**Subject:** FW: 224270 - Land to the north of Hedgerow Way, Holmer, Hereford, Herefordshire, HR4 9RG

For the avoidance of doubt, the finish floor level to plot 485 has been updated. No other changes have been made, nor requested. Hopefully the LLFA are in a position to remove the objection.

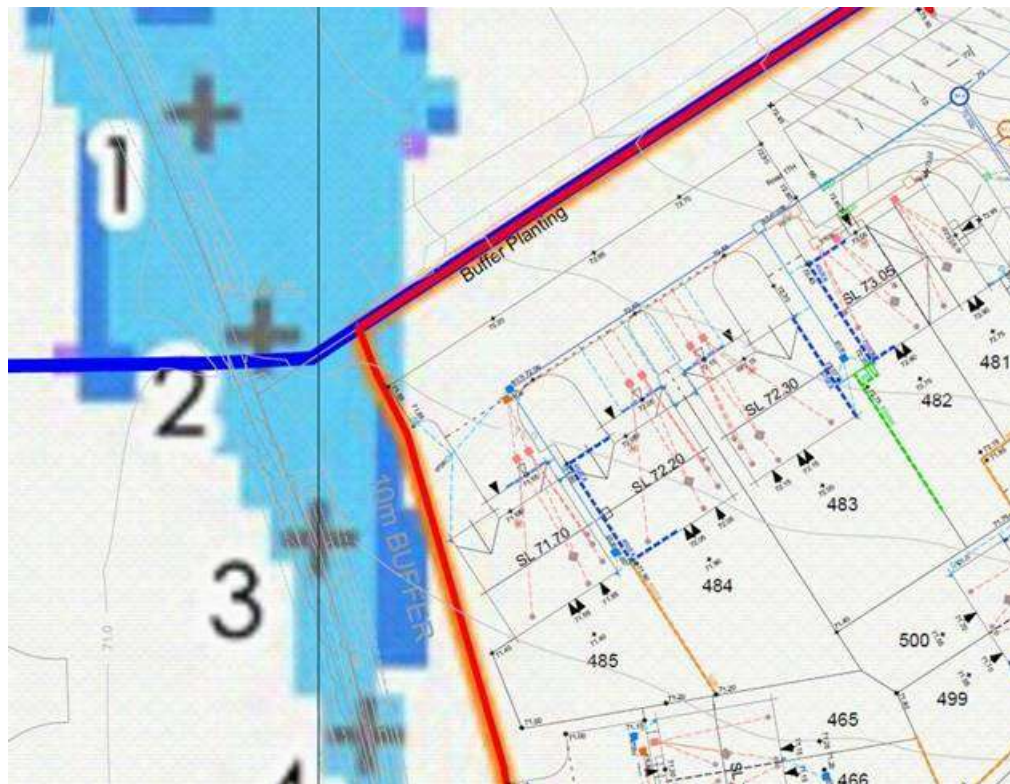
Whilst we would have no issues raising this slab level by 150mm to reference flood level Point 2, the overlay provided below clearly shows that Point 2 is outside of the boundary to our development. The FRA also states;

The private driveway which would be the nearest development to point 2 has already been designed above the 71.85 AOD level and therefore the water from Point 2 would not be able (in principle) to breach the driveway and get to the plot (extract below)

Thanks for clarification, however we feel that cross section2 would be the appropriate node to use for determining the levels for plot 485, the FRA is ambiguous and non-committal in

clarifying which cross section to use. Therefore based on 600mm above 71.25, the slab level should be a minimum of 71.85mAOD.

Regarding the flood levels, the development (Closest Plot 485) is between Point 3-4 of the flood model and therefore we used the values of Point 3 (worse case) to determine the minimal level of the plot required (as per extract below)

Please find attached for information updated planning drawing showing the revised slab level as requested for plot 485.

We think that the plot 485 should be at 71.85m

Based on the above, the minimum level required for Plot 485 would be **70.38** (69.78+600mm). Therefore our slab level (**71.70**) provided are some 1.32m above this minimal level required as part of the FRA assessment.
